## Memorandum Planning and Development Services

**RE:** **Schoettler Grove – Fence Modification Request:** Reconsideration for fence material for a 17.0 acre tract of land zoned “PUD” Planned Unit Development located northwest of the intersection of Clayton Road and Schoettler Road and known as Schoettler Grove.

**RE: Schoettler Grove Fence Proposal**

Enclosed in this letter is the proposal to modify the fence originally approved by the City of Chesterfield in Revision 12 dated 3/19/15. Attached for your reference are associated pictures and shop drawings related to this proposal.

Fence

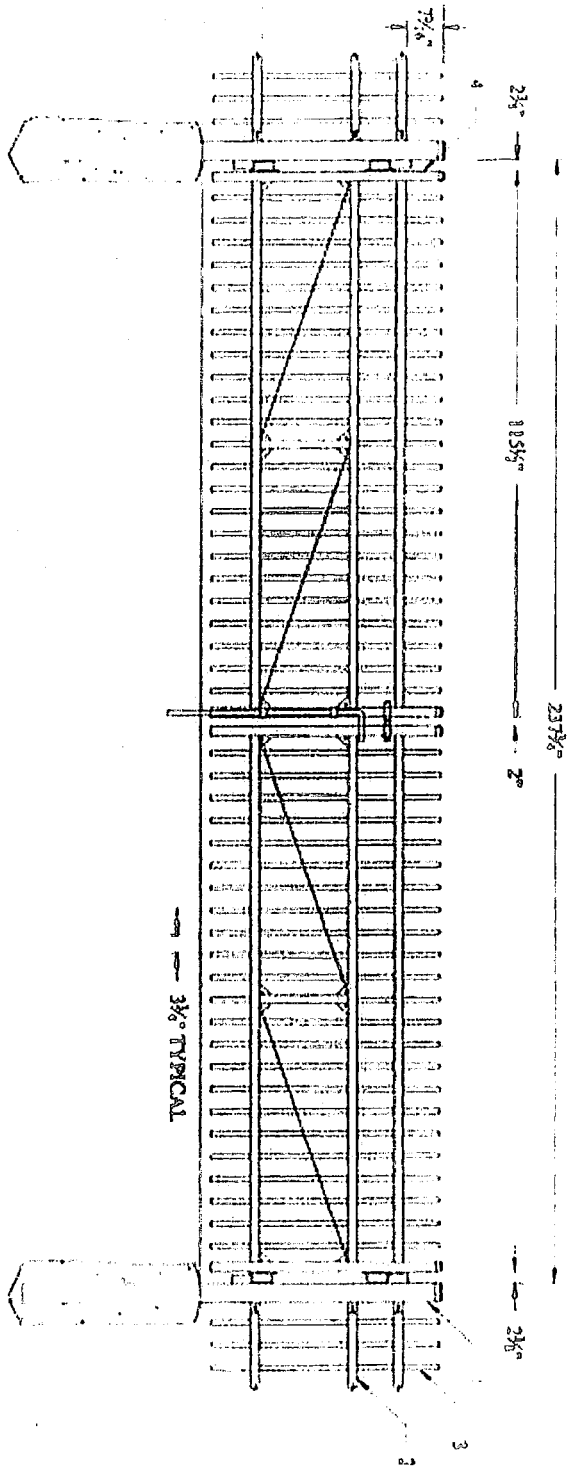
Our research has found no company that manufactures a fence system with steel posts and aluminum pickets. Aluminum fences require punched posts at the intersection of the rail and the post and steel fences have brackets that wrap around the post to connect the rails. In addition there are no manufacturers that make anodized aluminum fencing.

Since we were unsuccessful in our research, we propose to use aluminum posts and pickets for all fencing as well as the emergency access road gate. The fence and emergency access road gate will be the exact same style and color as the previous fence submittal.
